# Broadcast Products

## Technical Bulletin 20-2009-128

SUBJECT: PEDESTAL LEVEL OF TEST SIGNAL UNDULATES  
ON RIGHT AND LEFT SIDES

MODEL: *HDC1000//ULW*  
*HDC1000/LB*  
*HDC1000/LW*  
*HDC1000/LW*  
*HDC1400//UL*  
*HDC1400/L*  
*HDC1450//UF*  
*HDC1450/K*  
*HDC1500//UL*  
*HDC1500/L*  
*HDC1500/L*  
*HDC1550//UF*  
*HDC1550/K*  
*HDC1580/L*  
*HDC1580/T*

#### TG-243 Board (Side B)

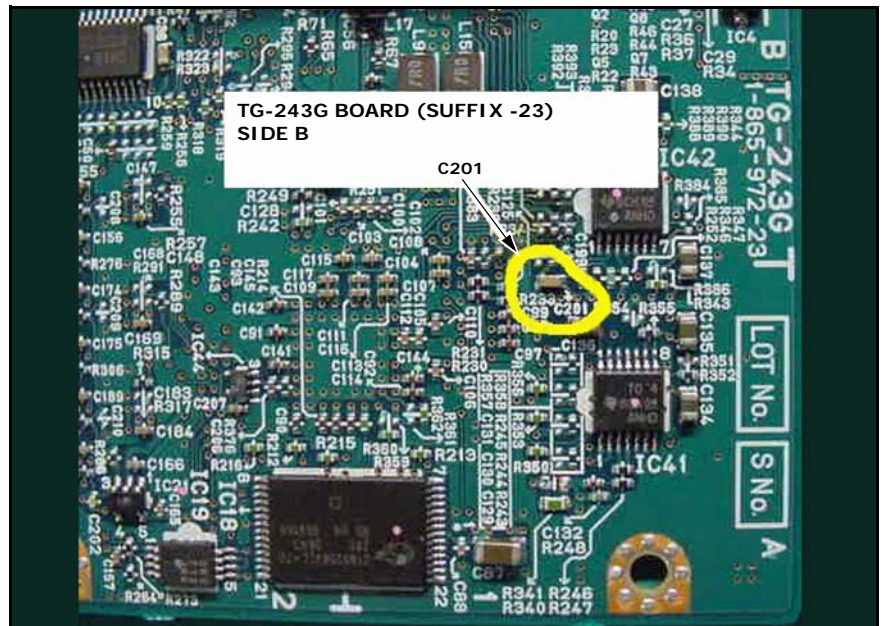
The pedestal level of the analog test signal (TestSaw/3-step) waveform may undulate on the right and left sides. This symptom occurs when a TG-234G board with suffix -23 is used in the CCD block.

1. Remove the TG-243 board as described in the service manual, volume 1, section 2-2, "Replacement of CCD Unit Boards."
2. Replace C201 with a new 4.7  $\mu$ F capacitor. (See Figure 1.)
3. Reinstall the TG-243 board and CCD unit.
